Reference: Ogden Martin Systems of Lake, Inc.
DRAFT Initial Title V Air Operation Permit No. 0690046-001-AV
Supplemental Response Document Dated October 19, 2000

DRAFT Initial Title V Air Operation Permit No. 0690046-001-AV Supplemental

Response Document Dated October 19, 2000

PART 2 : RESPONSES TO COMMENTS

FIGURE 8

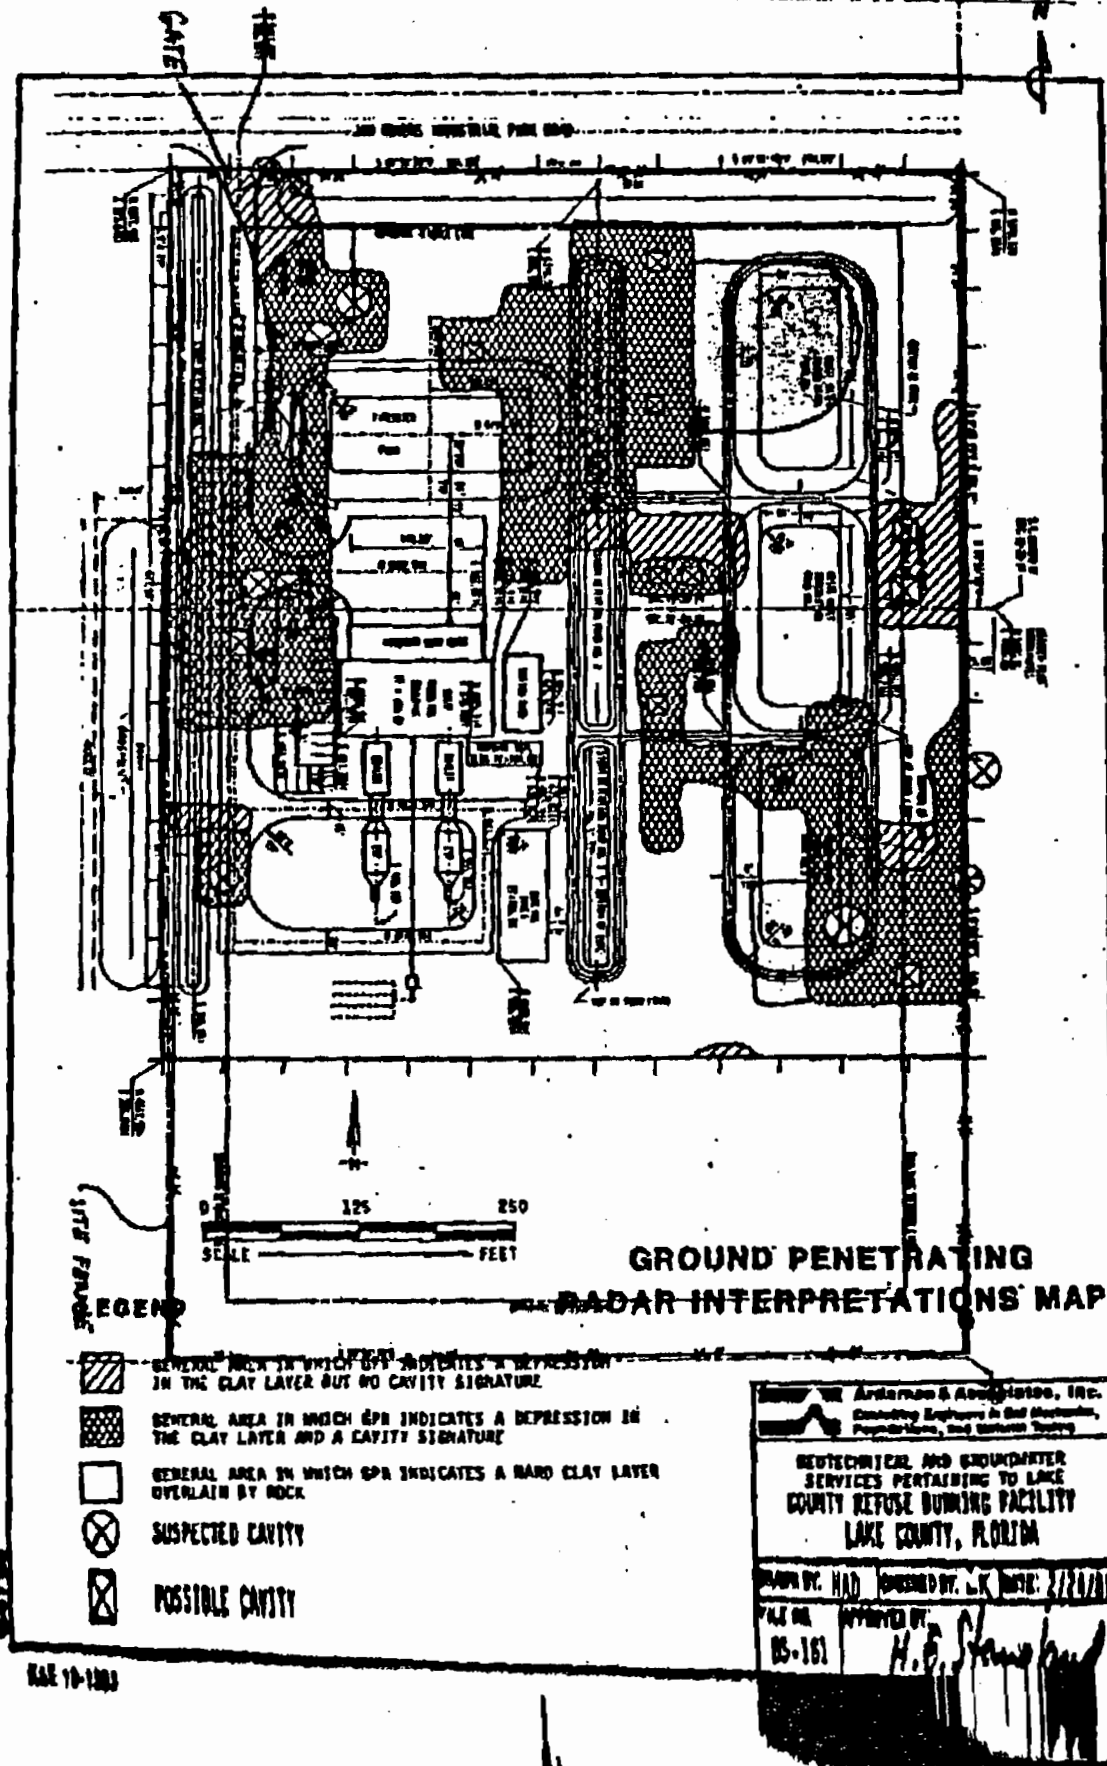
LETTER ITEM NO. 4 RESPONSE:

Refer to the attached Site Plan/Ground Penetrating Radar Interpretations Map overlay which shows that no major structures will be constructed over any areas of suspected or possible cavities or areas with a cavity signature.

The strength of the subgrade and soil bearing capabilities have not been determined at this time. Geotechnical services will be initiated upon approval of subject construction permit application. The strength of subgrade and soil bearing capabilities will be determined in accordance with ASTM Standards D1586, D1587, D2113, and D2488. Foundation systems will be designed according to the Geotechnical Engineer's recommendations to ensure imposed loads and stresses will not exceed allowables.

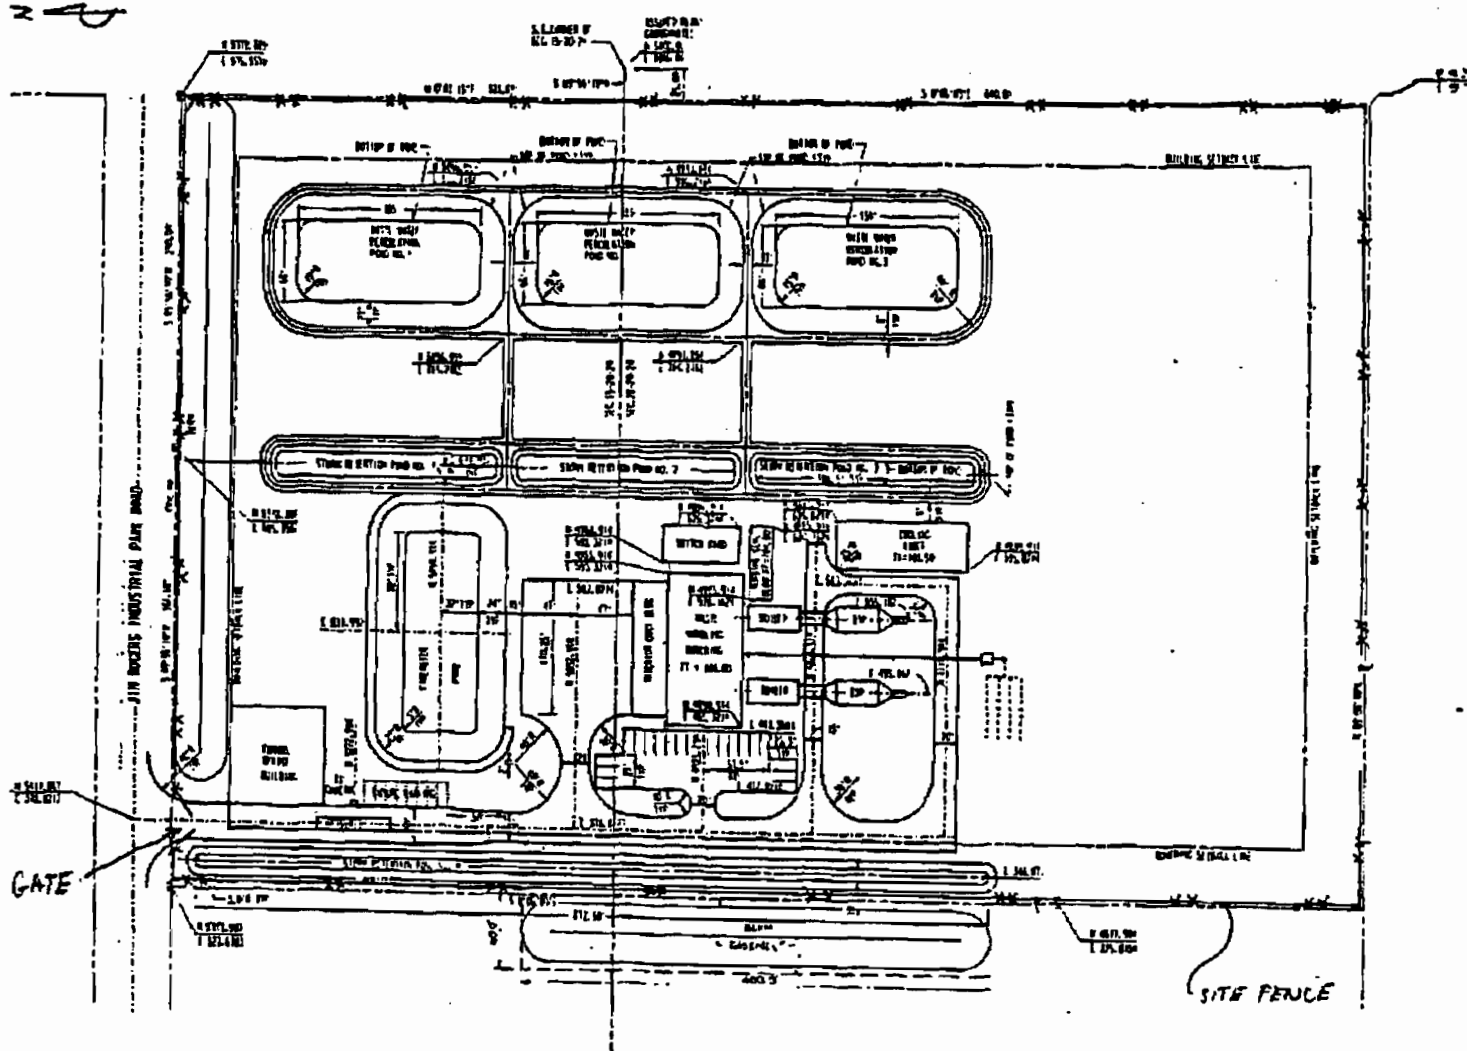
LETTER ITEM NO. 6 RESPONSE:

1. Refer to the attached sketch of site drawing showing location of fencing and gate. Note that the entire perimeter of the property is to be fenced.
2. Refer to attached sketch of the site fire protection system showing location of fire hydrants, fire pump house, post indicator valves, isolation valves, and feeds to sprinkler systems inside buildings.

B. The firewater pond will serve as a storage reservoir for water to fight fire(s). The firewater distribution piping and hydrants will be fed by fire pumps taking suction from the fire water pond. The pond will have a volumetric capacity to supply 2000 GPM flow for four hours. A community well will serve as a source of makeup to the firewater pond. A city fire hydrant system exists along the frontage road.
